UNC Wilmington Alderman and King Hall Renovation

SCO ID#: 22-24639-01A

Addendum Number 4: August 30th, 2023

Project: UNCW King Hall Renovation
601 Hamilton Drive
Wilmington, NC 28403

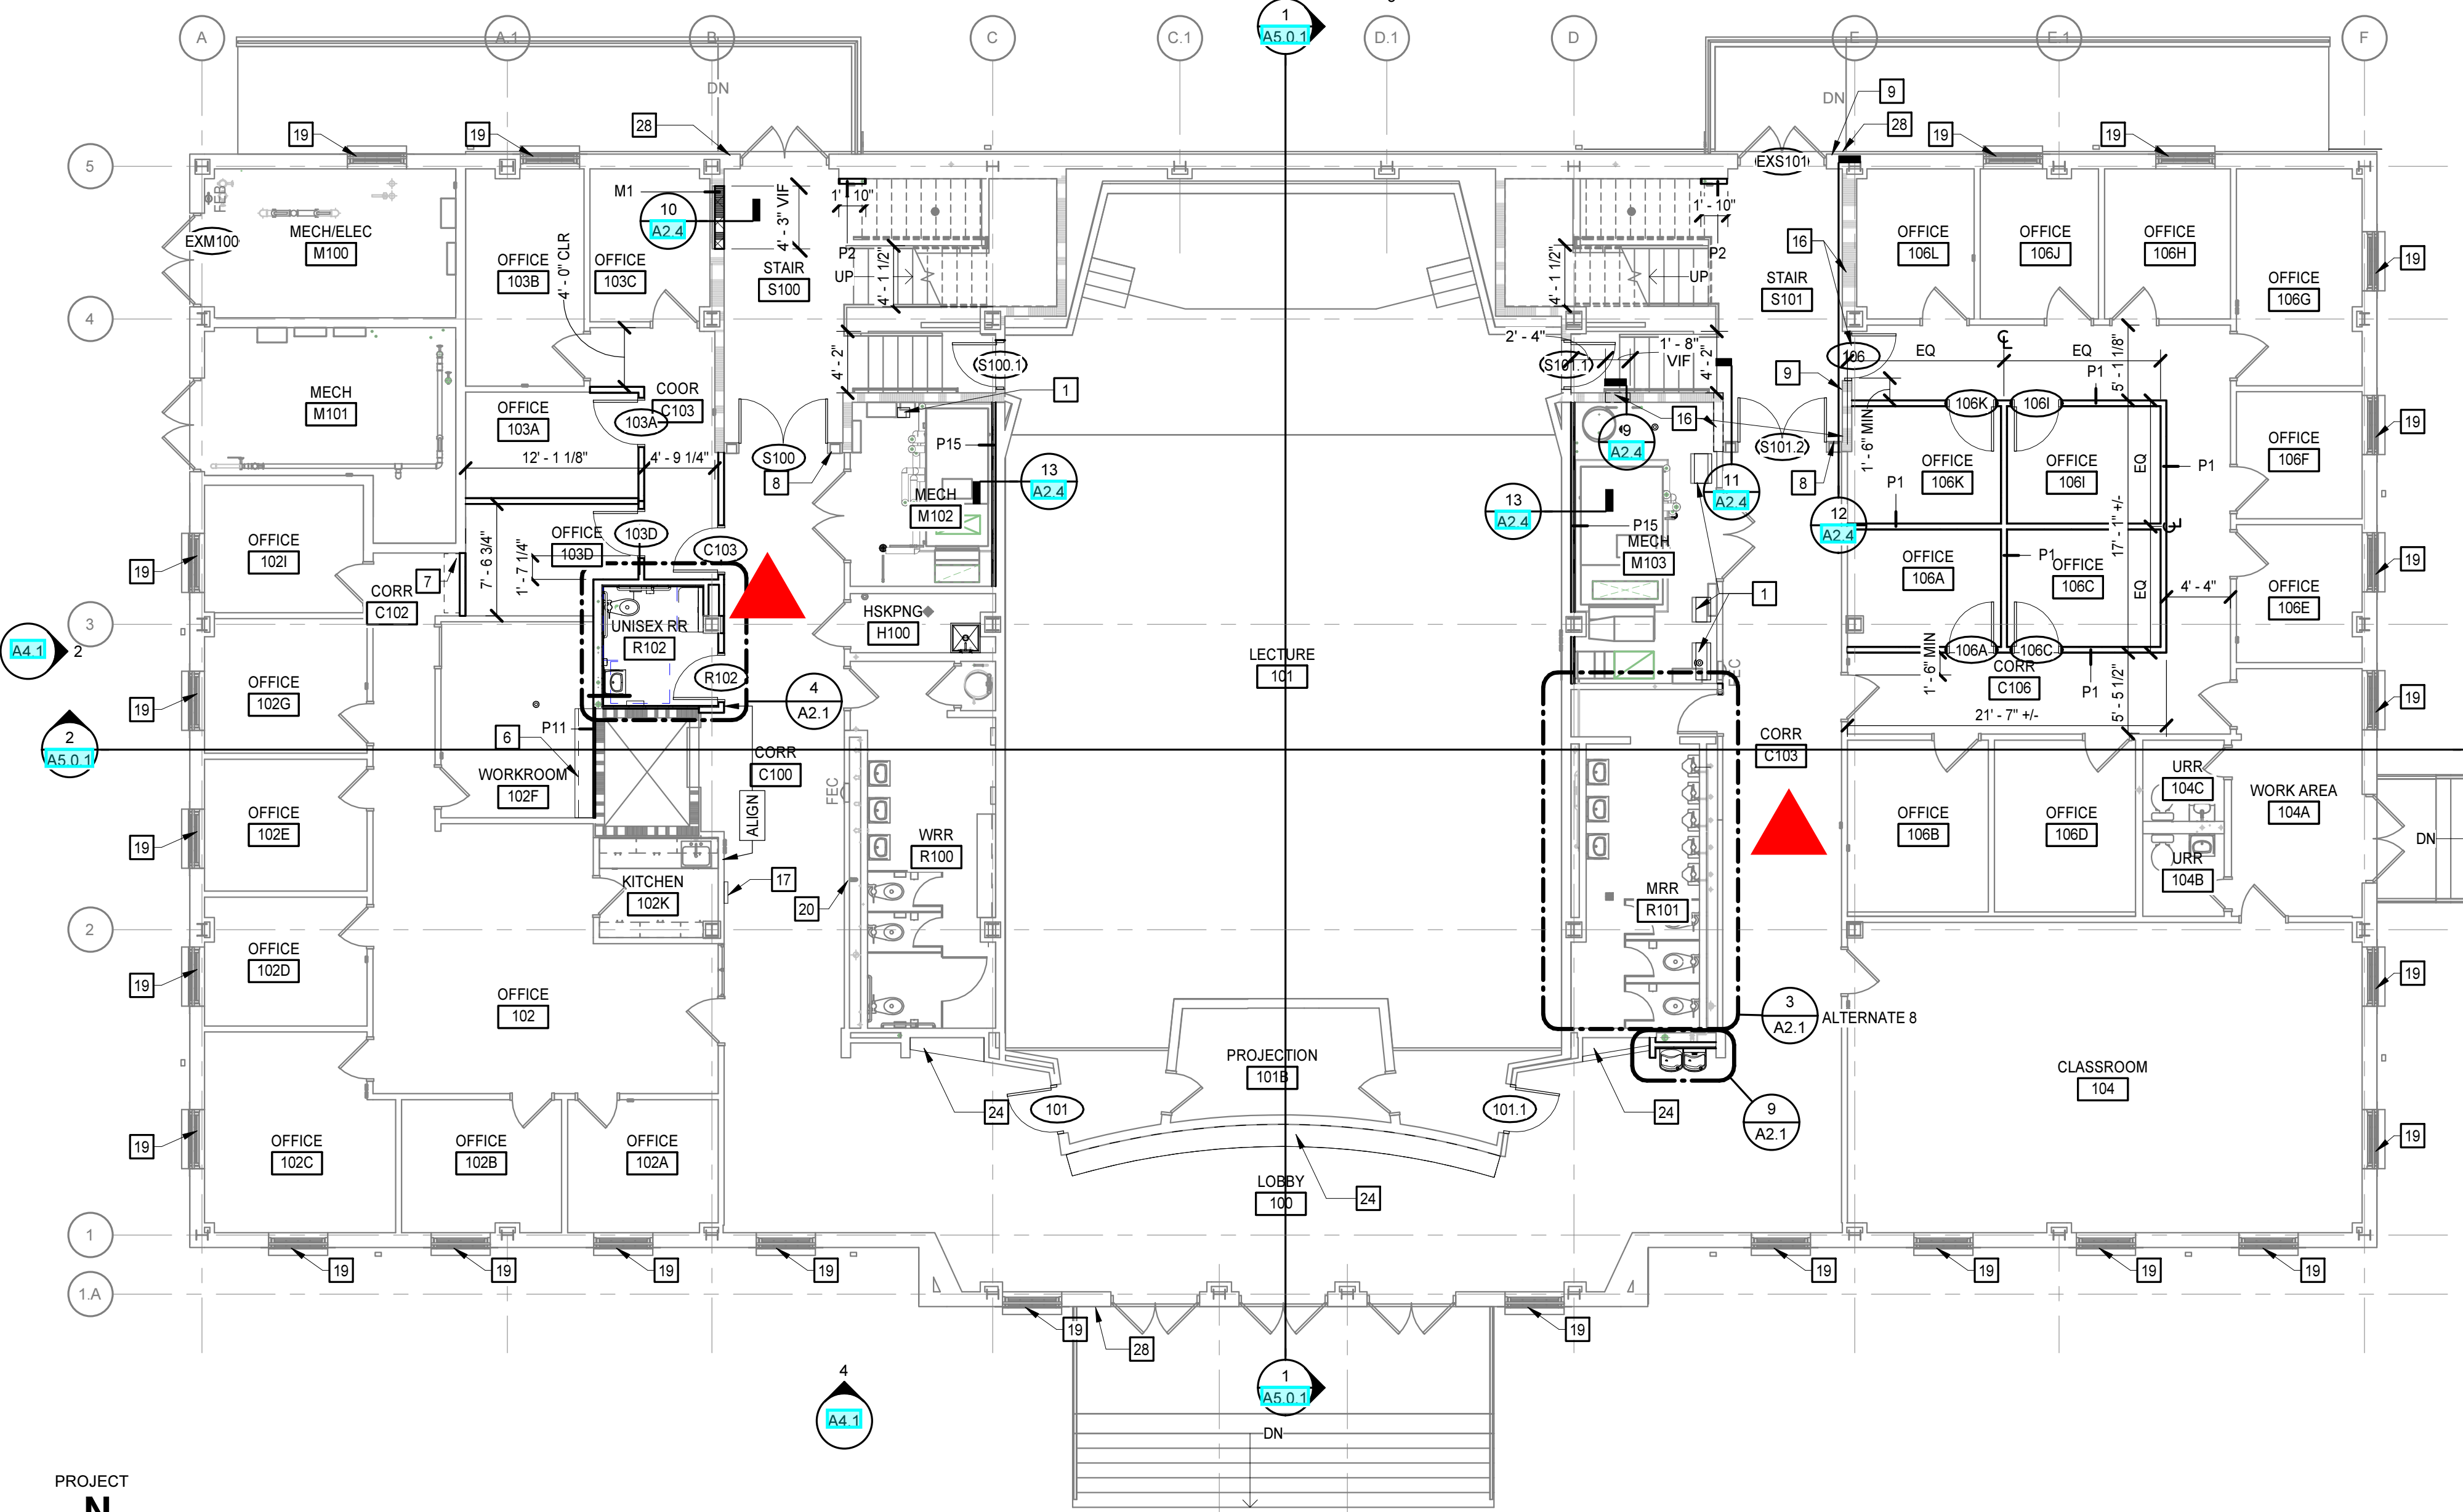
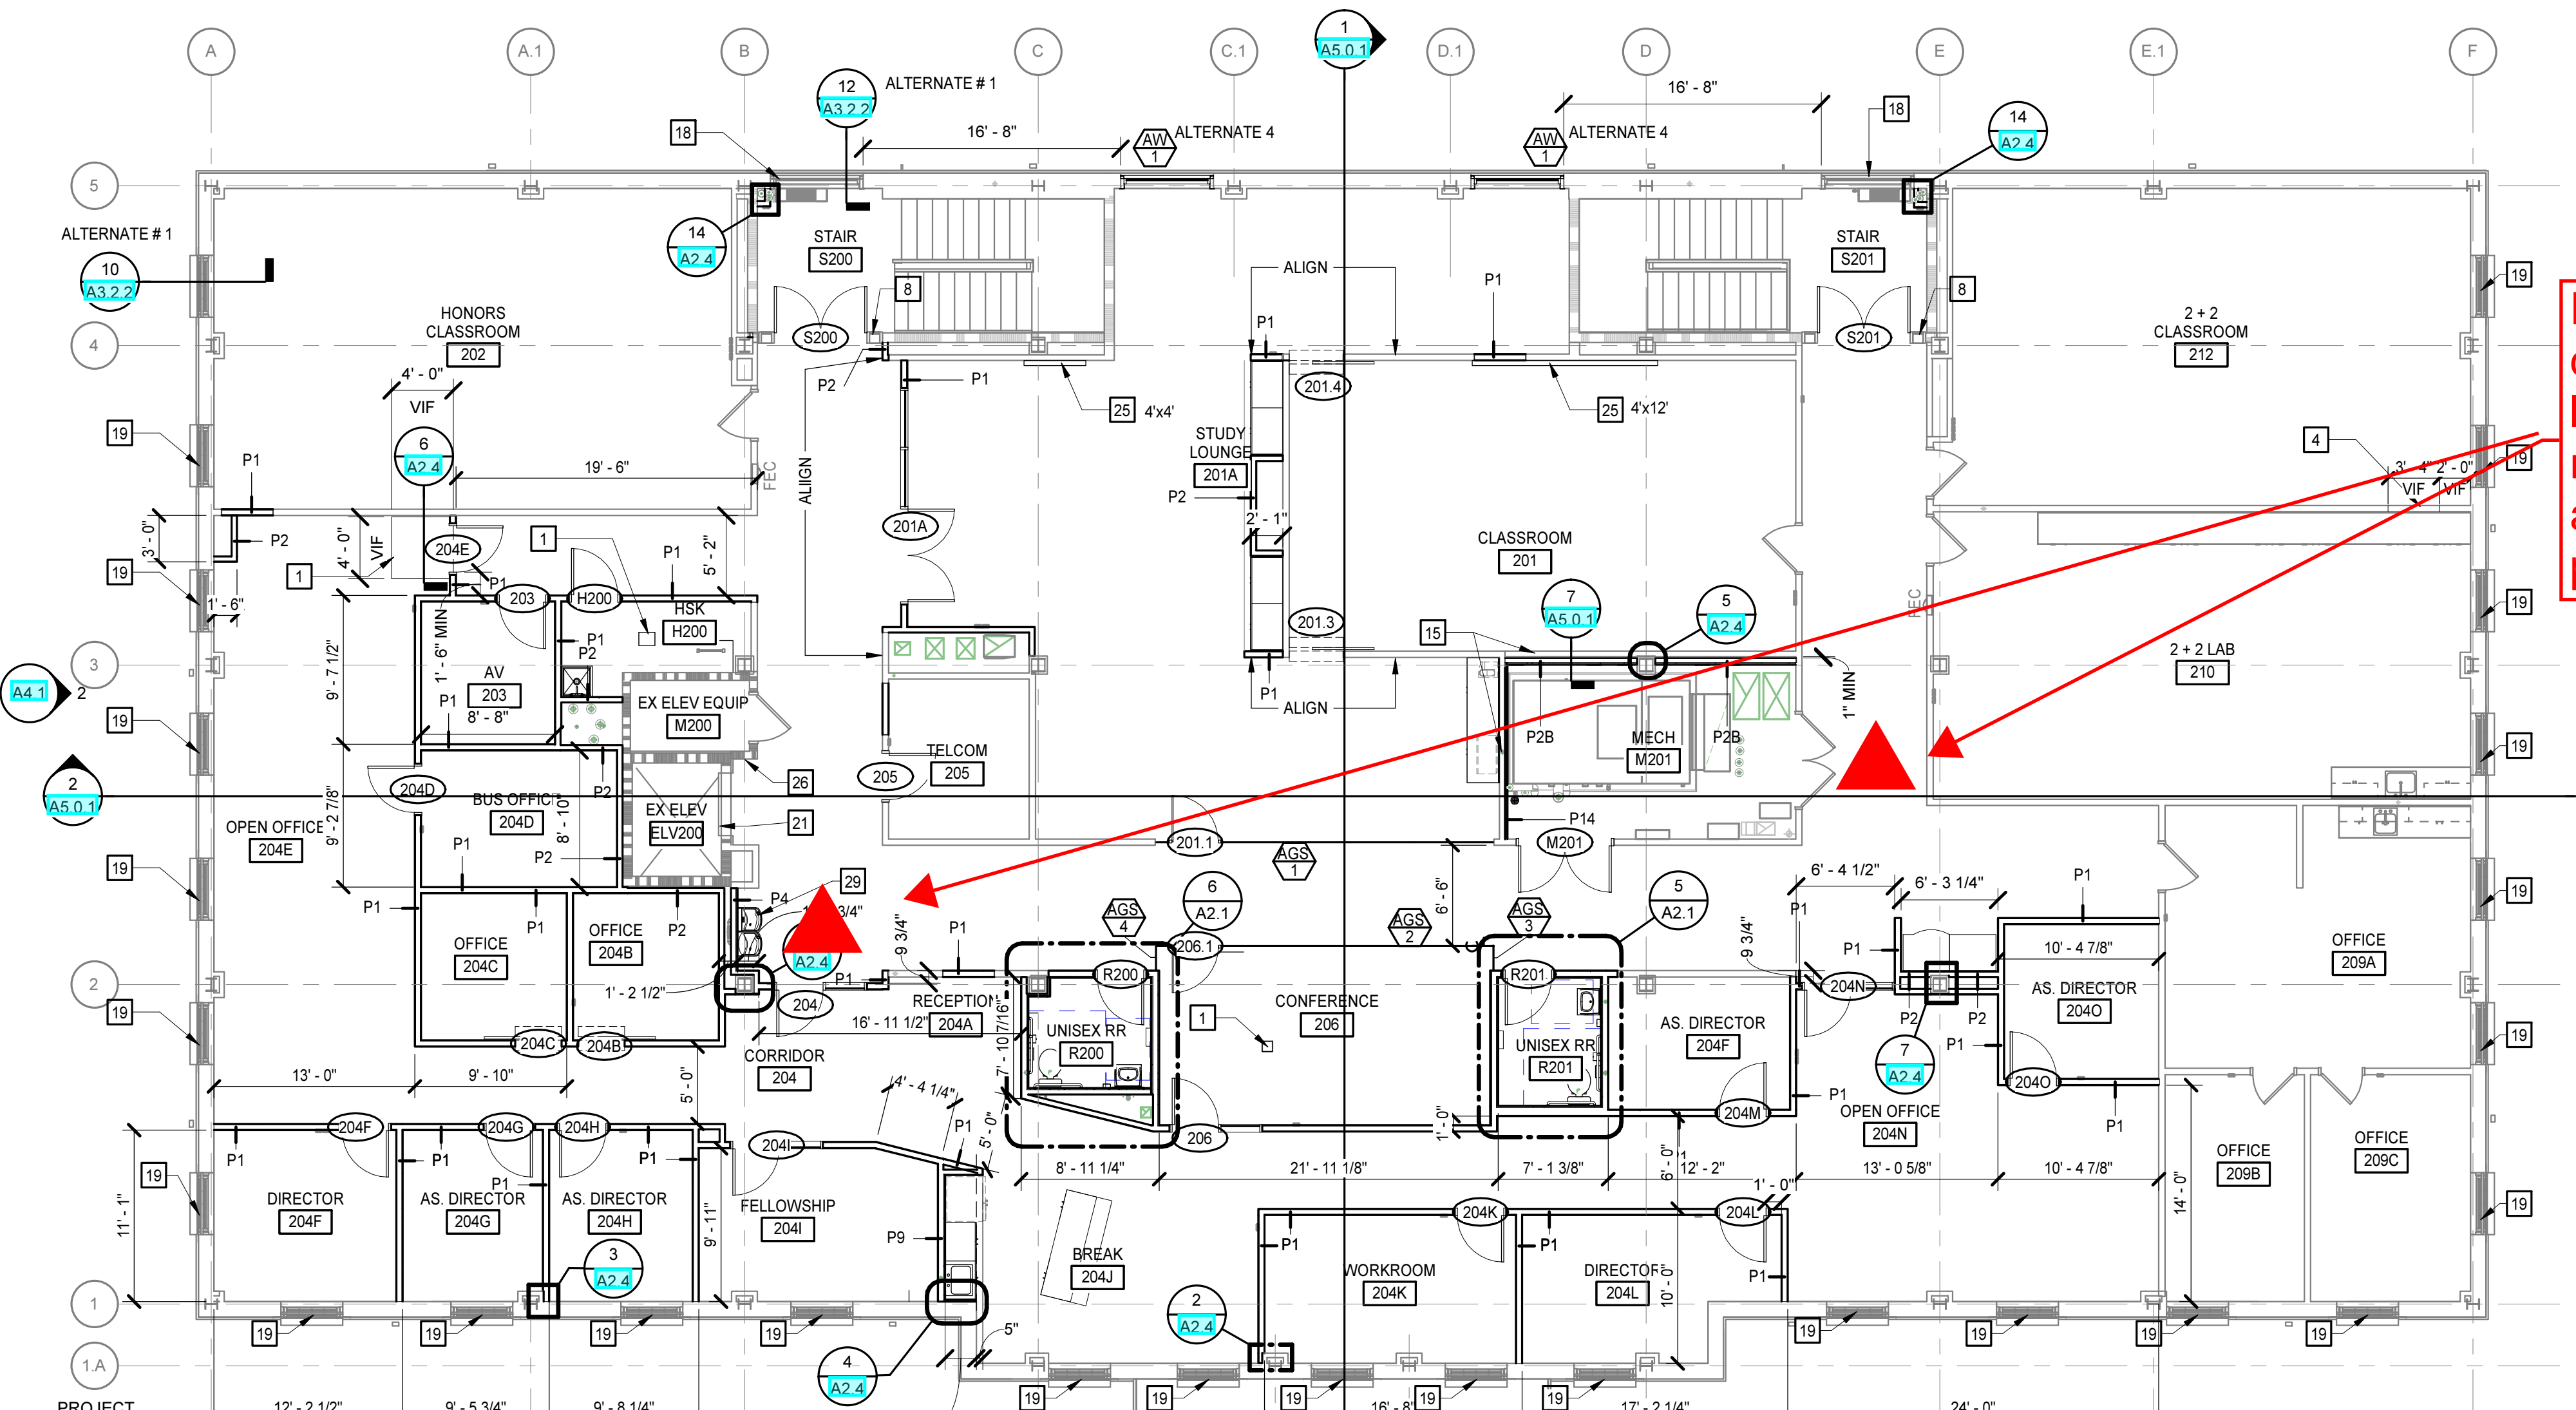
- f. **Question:** Per discussion temp power will be needed. We could install temp stands per discussion, or install GFCI receptacles in areas that will not be effected by demo. Using the temp stands would eliminate confusion to make sure GFCI protected outlets are used. Another option would be to use GFCI protected pigtail in existing duplex outlets. These are relatively inexpensive and could be used in areas that demo is not required.

Answer: See attached layout plan titled *Temp Power Plan* indicating quantity and approximate location of temp. power stands for use during construction. These shall be provided, installed, maintained and removed by the electrical contractor.

Proposed locations of Temp. Power Stands during construction. EC shall coordinate locations with Muter Superintendent. Provide a minimum of 2 per floor. More may be required and EC shall provide if necessary for temporary power requirements during construction.
